CBD AND SOUTH EAST LIGHT RAIL PROJECT

STATE SIGNIFICANT INFRASTRUCTURE APPROVAL (SSI-6042)

MODIFICATIONS REPORT

DECEMBER 2014

Figure 3.22 Revised tree impacts resulting from the modified Alison Road alignment and relocated Royal Randwick Racecourse stop location

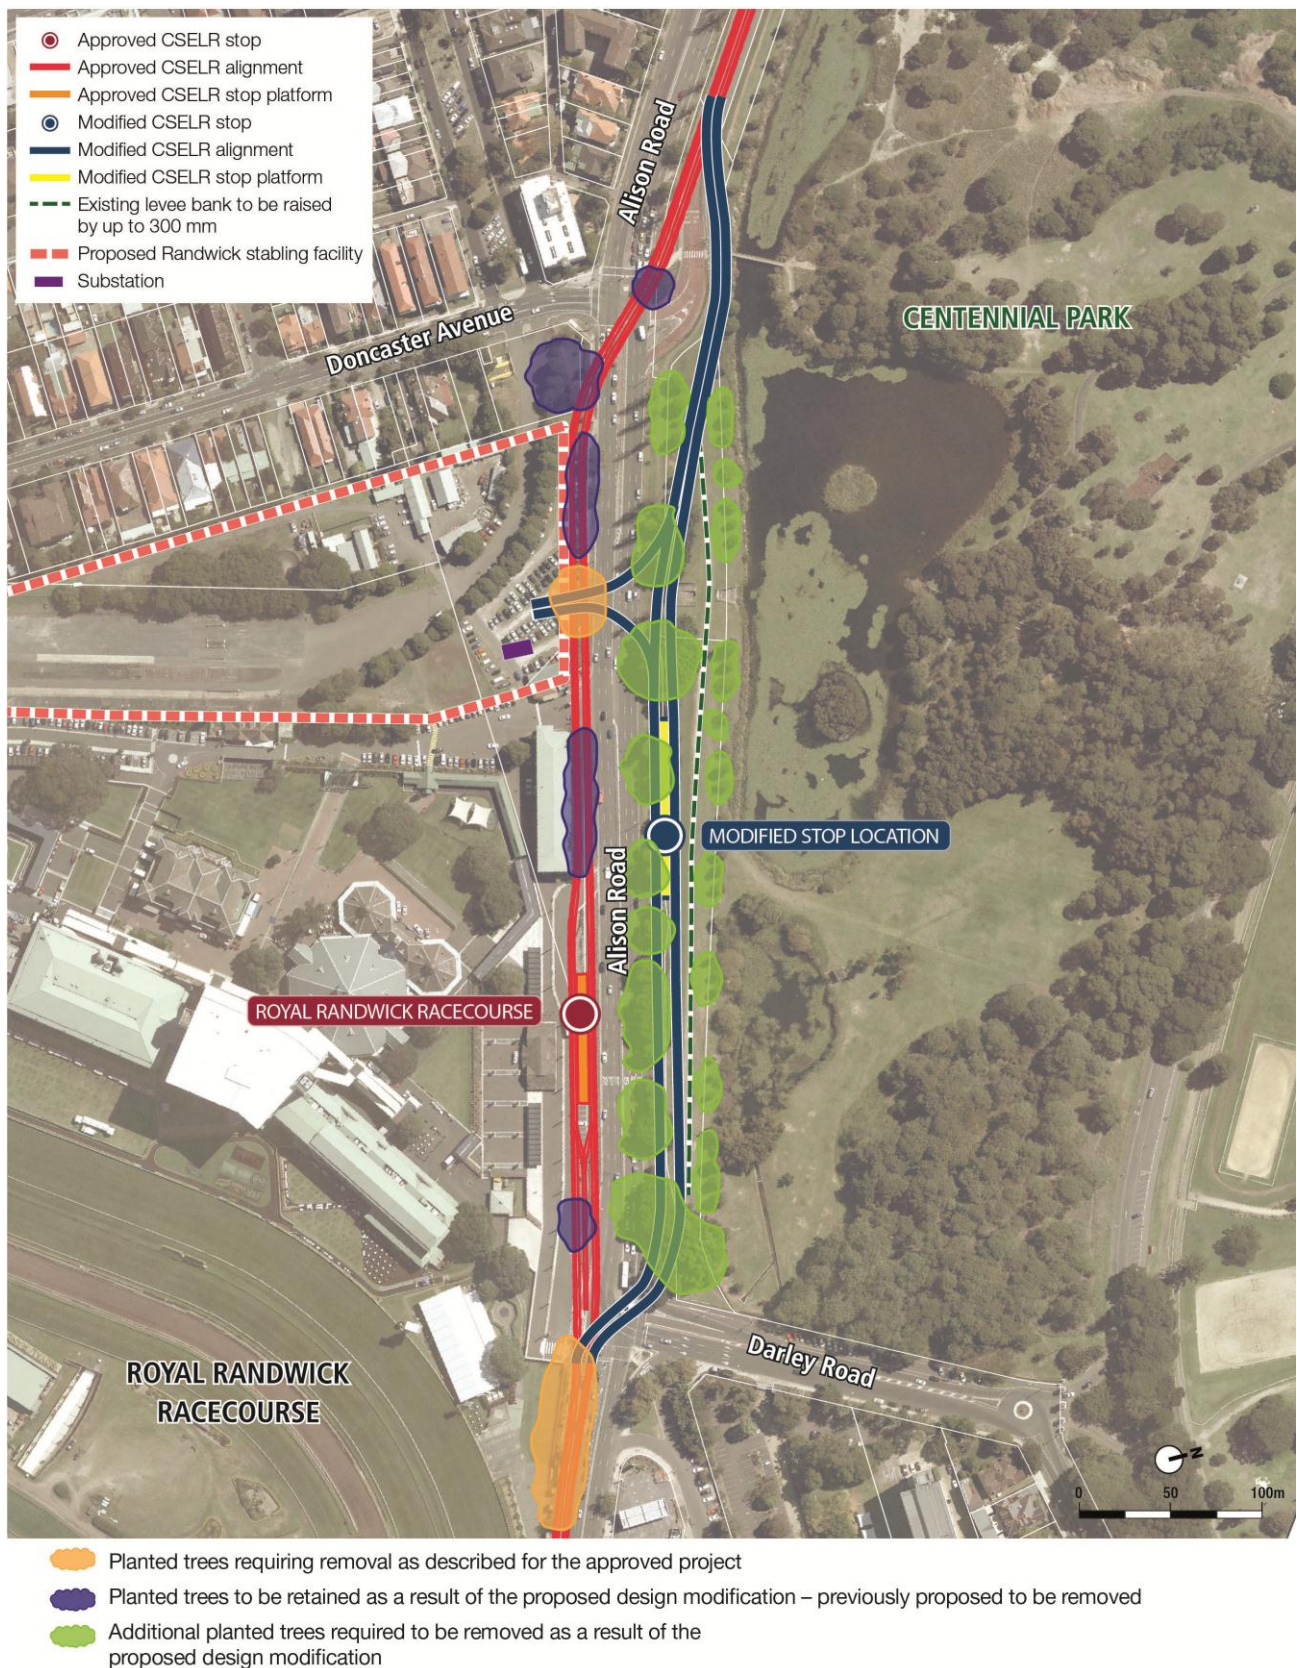
The modified design in this location would include the removal of approximately 50 trees along Alison Road between Doncaster Avenue and Darley Road. These include some significant fig trees and a row of smaller juvenile paperbark trees to the north of Alison Road adjacent to the Kensington Ponds (refer to Figure 3.22). The revised alignment would however no longer impact on approximately 25 trees which were previously proposed to be removed as part of the approved alignment. Therefore, the proposed modification would impact on approximately 25 additional trees compared to the approved design.

Figure 3.23 Proposed light rail alignment at the Anzac Parade/Alison Road intersection

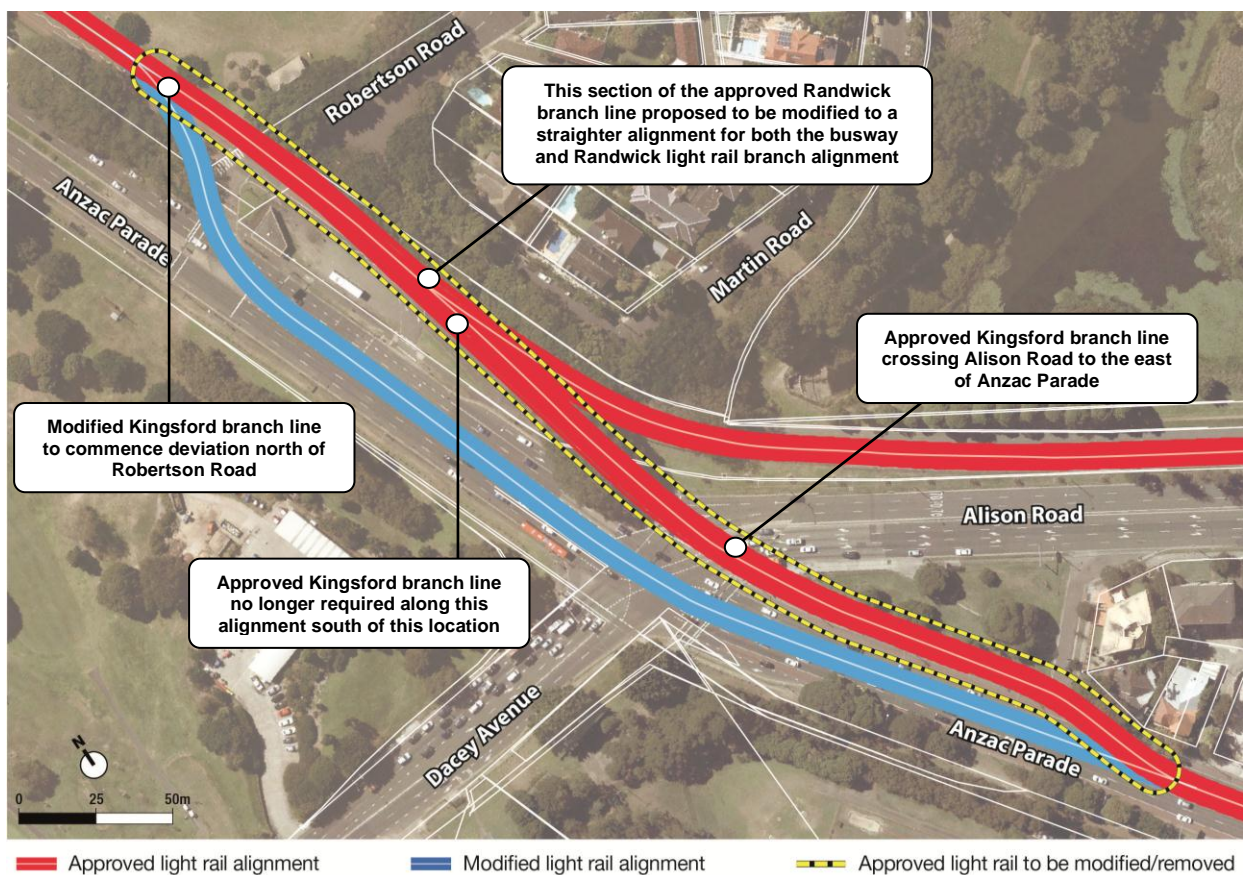
For the modified design, the light rail would branch into their separate alignments at Robertson Road. The Kingsford branch line would shift west into the centre of Anzac Parade, approximately 300 metres prior to the intersection of Anzac Parade and Alison Road. The Kingsford branch would then continue through the Anzac Parade/Alison Road intersection as a centre running alignment along Anzac Parade (refer to Figure 3.23). The modified design would result in benefits to the approved project including removal of the proposed impact to Tay Reserve and improved light rail operations through the Anzac Parade/Alison Road intersection.

The straightened alignment for the busway and Randwick branch would occur between Robertson Road and Martin Road, resulting in the alignment being slightly closer to Martin Road. The alignment of the shared running alignment between Anzac Parade and Tay Street (to the south-east) would not be changed as a result of the proposed modification. An indicative layout of the modified light rail alignment at the Anzac Parade/Alison Road intersection is shown in Figure 3.23.

Figure 3.26 Proposed staging of the modified construction methodology for the Moore Park tunnel

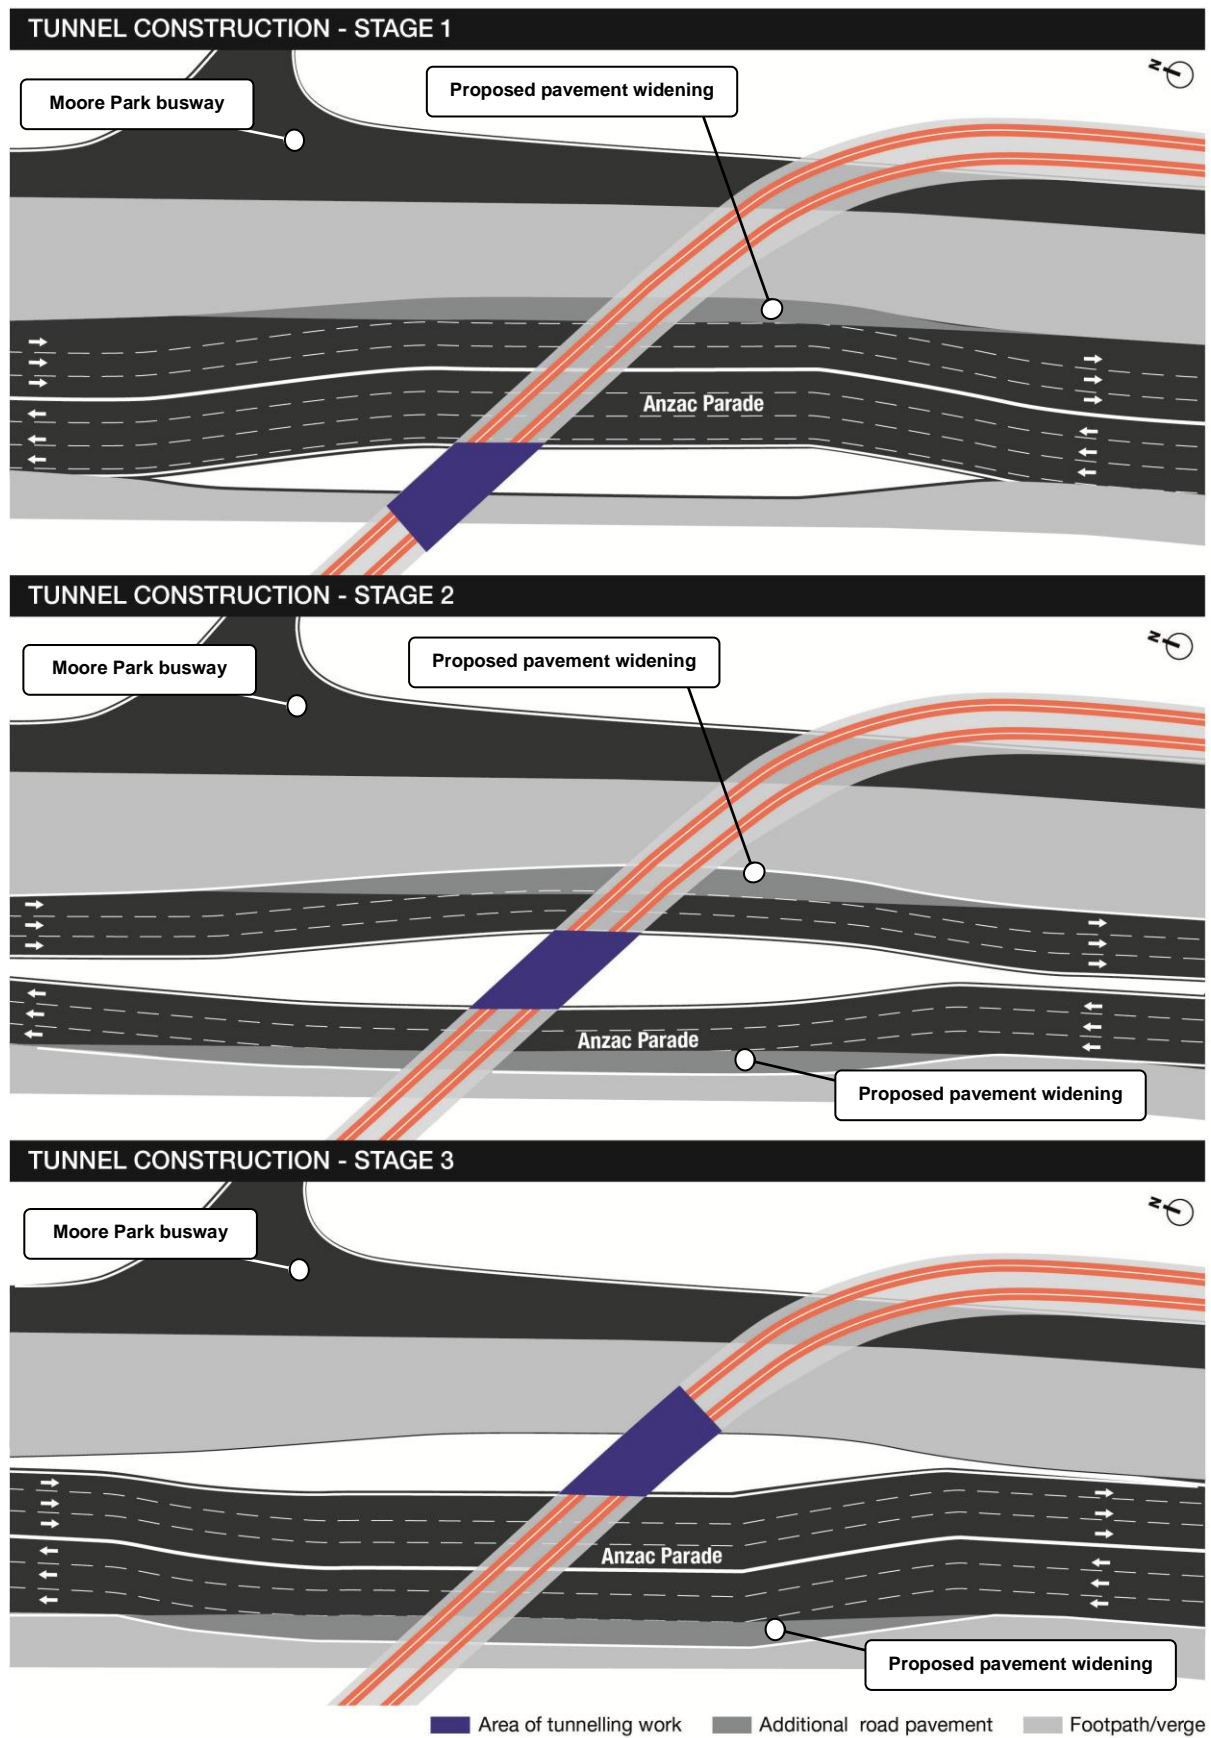
The tunnel crossing would be staged to maintain traffic capacity along Anzac Parade. This would require temporary realignment of Anzac Parade for approximately 100 metres either side of the tunnel crossing to enable the traffic to be adjusted as the tunnel advances across the roadway. This would be undertaken in three main stages (to enable three traffic lanes to be maintained in each direction for each stage of the tunnel construction). To maintain three lanes in each direction, temporary road pavement would be required to be constructed for the length of the diversions within the existing footpath areas on both the eastern and western sides of Anzac Parade. Following completion of the tunnel construction, the temporary pavement would be removed and the existing footpath and grassed verge reinstated.

An illustration of the indicative staging for the construction of the Anzac Parade tunnel and associated temporary traffic lanes is provided in Figure 3.26.

Figure 3.28 Proposed modification to the Surry Hills substation location

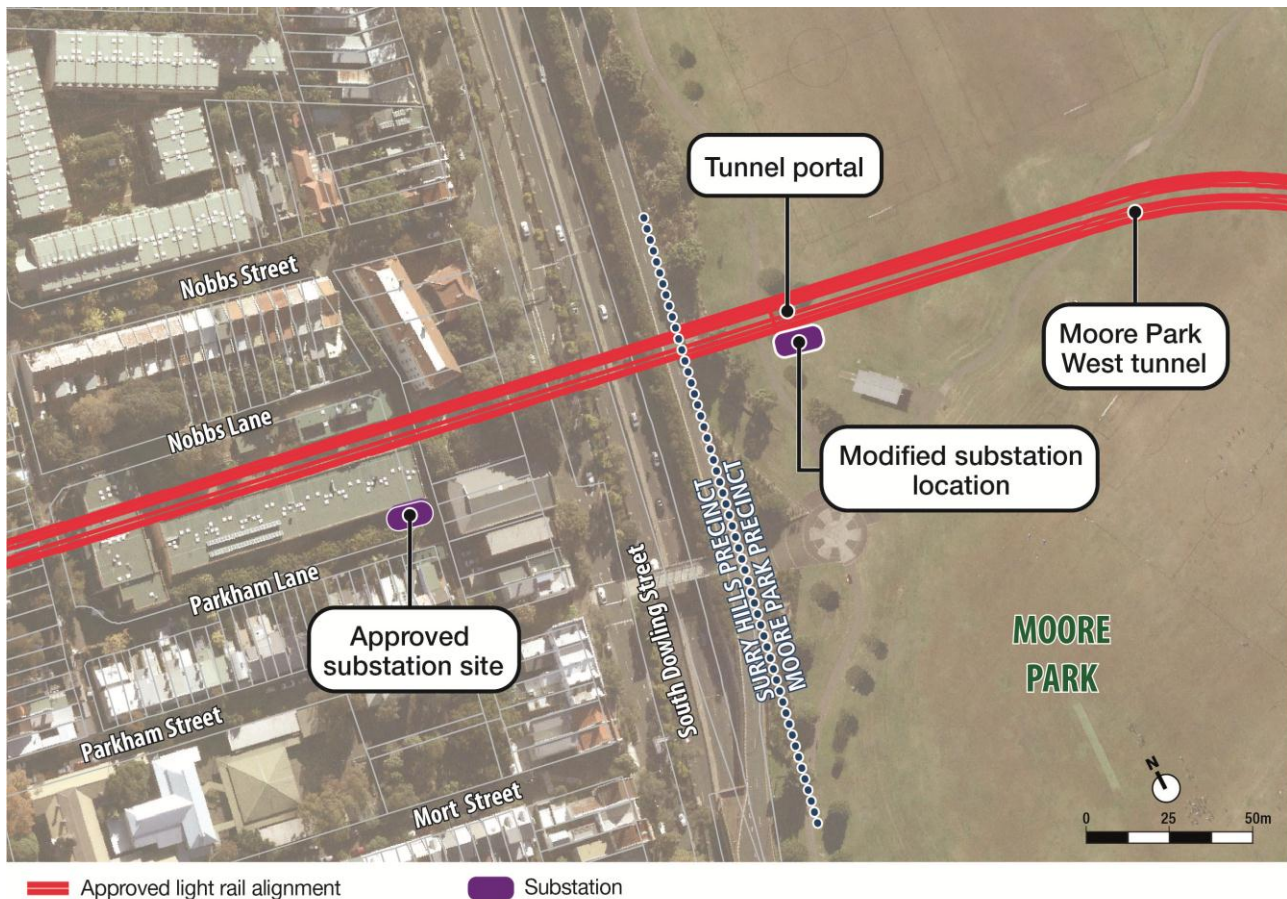
The location of the approved substation and proposed modified location are shown in Figure 3.28.

Figure 3.29 Plan of the proposed Randwick stabling facility identifying the location of the proposed sand silo

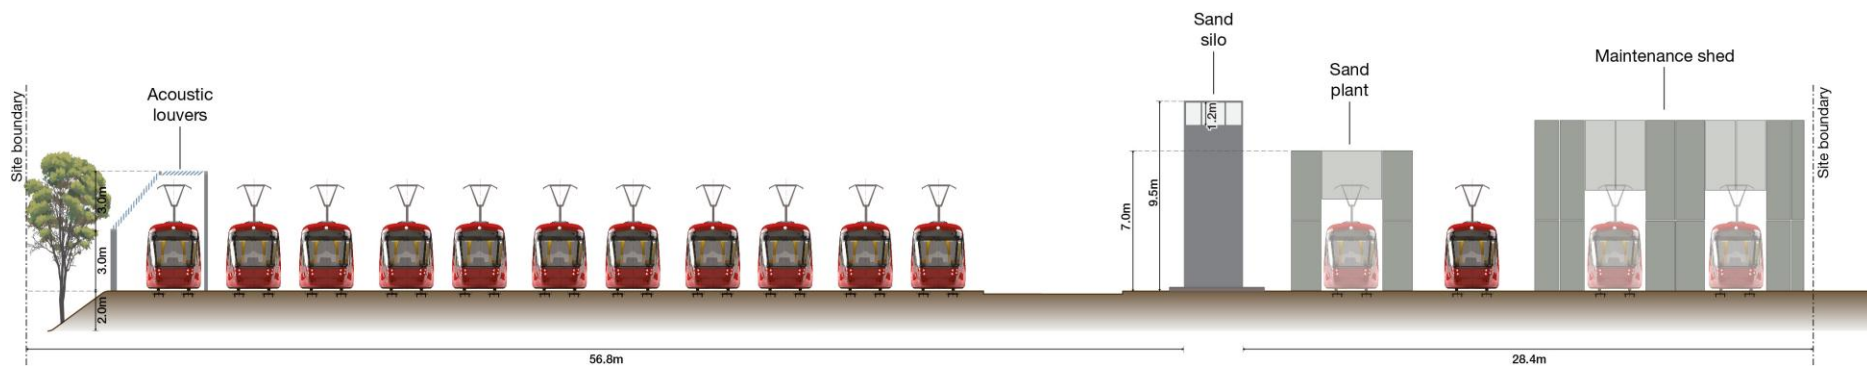
The proposed sand silo for the Randwick stabling facility is proposed to consist of a single silo stack, approximately 3.5 metres by 2.9 metres in width, with a height above the finished ground level of the site of approximately 9.5 metres. This silo will be located in a central area of the site, approximately 30 metres away from the site perimeter with the Royal Randwick Racecourse and approximately 50 metres away from the site perimeter with the residential area to the west. Taking into account the proposed fill to be provided on the site, this would result in a total height of this structure being approximately 11.5 metres above the existing ground level. This would represent an exceedance of the existing control limit identified in the conditions of approval by approximately one metre for this structure. A plan of the Randwick stabling facility is provided as Figure 3.29 and an indicative elevation of the proposed sand silo within the stabling facility is provided as Figure 3.30.

Figure 5.2 Proposed modification to the High Street LRV crossover location

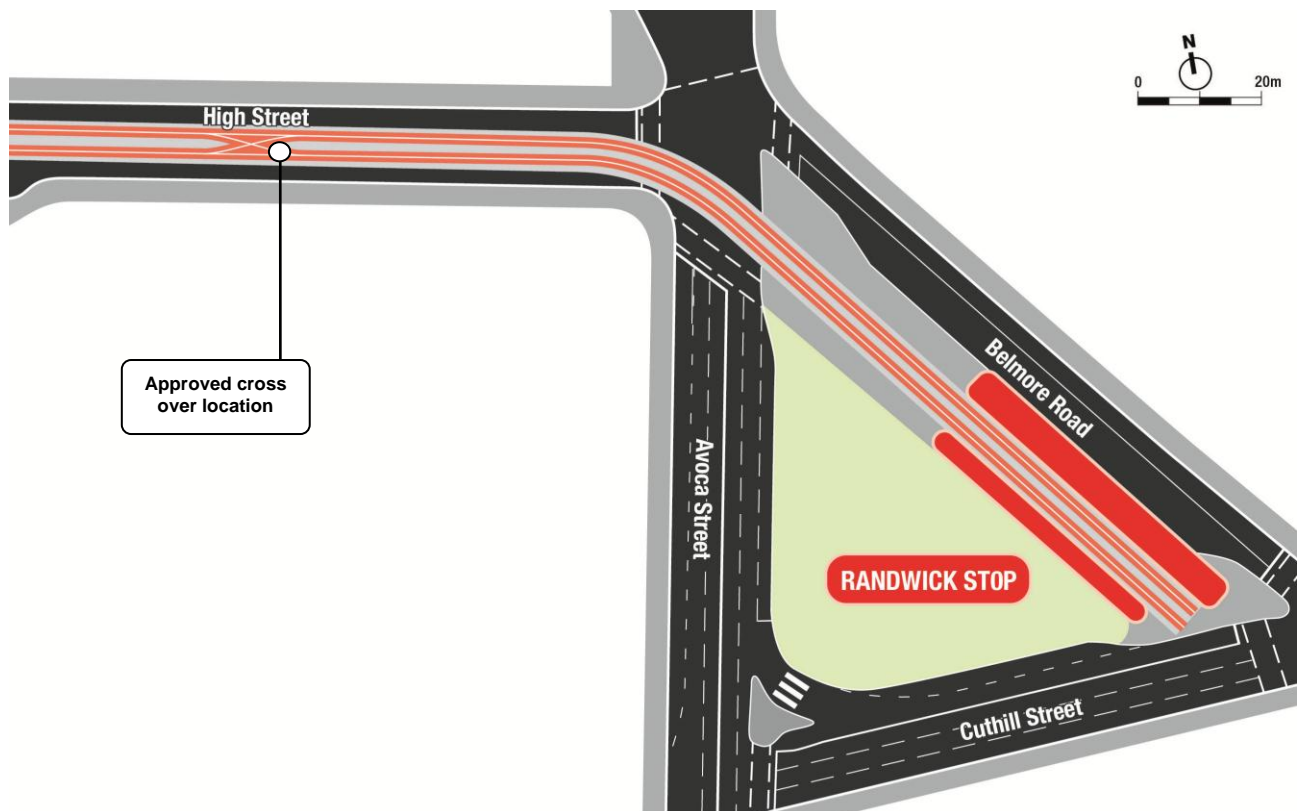
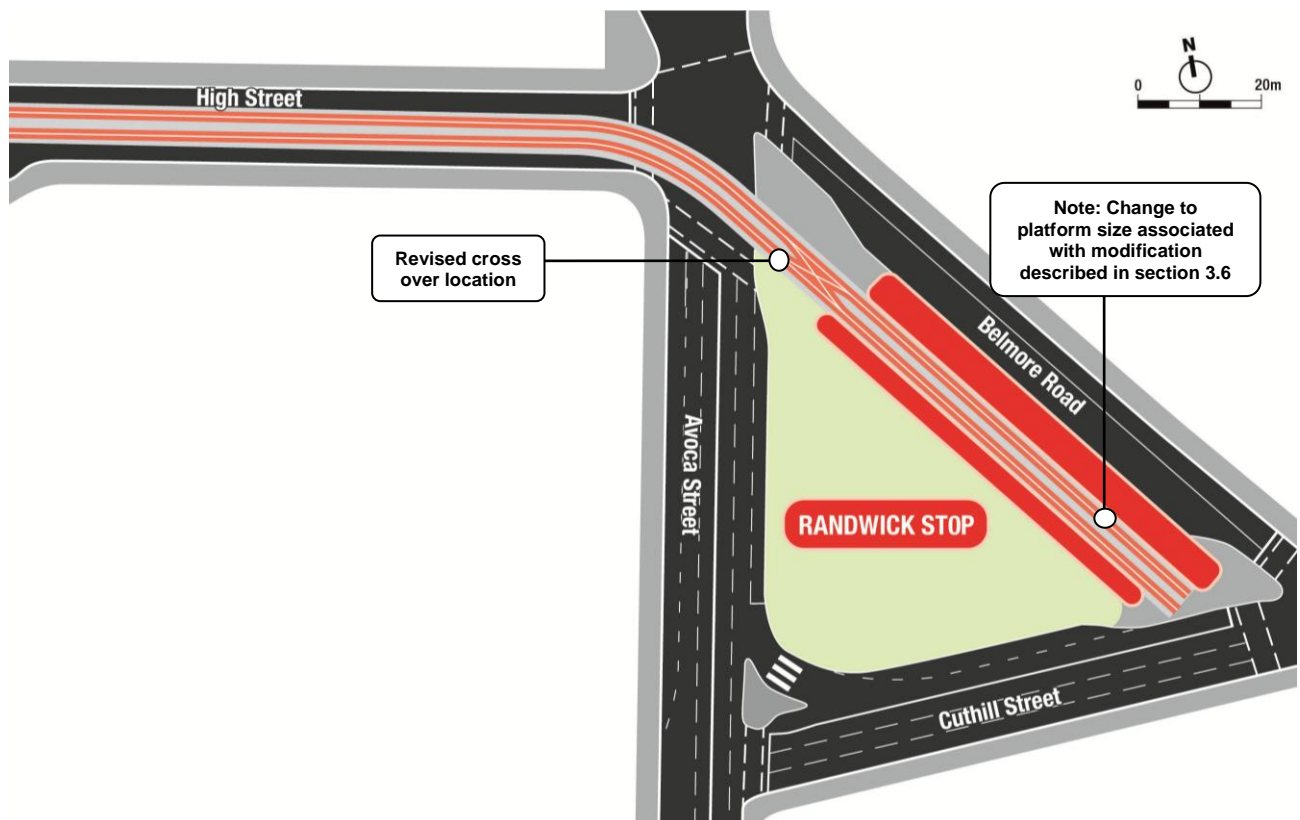
As part of the approved project, the light rail vehicle crossover (a track crossing point that would enable an LRV to cross between two parallel tracks) was proposed along High Street on the western side of the intersection between High Street and Avoca Street.

A comparison between the approved and the proposed design for the High Street LRV crossover location is provided in Figure 5.1 (approved) and Figure 5.2 (proposed).
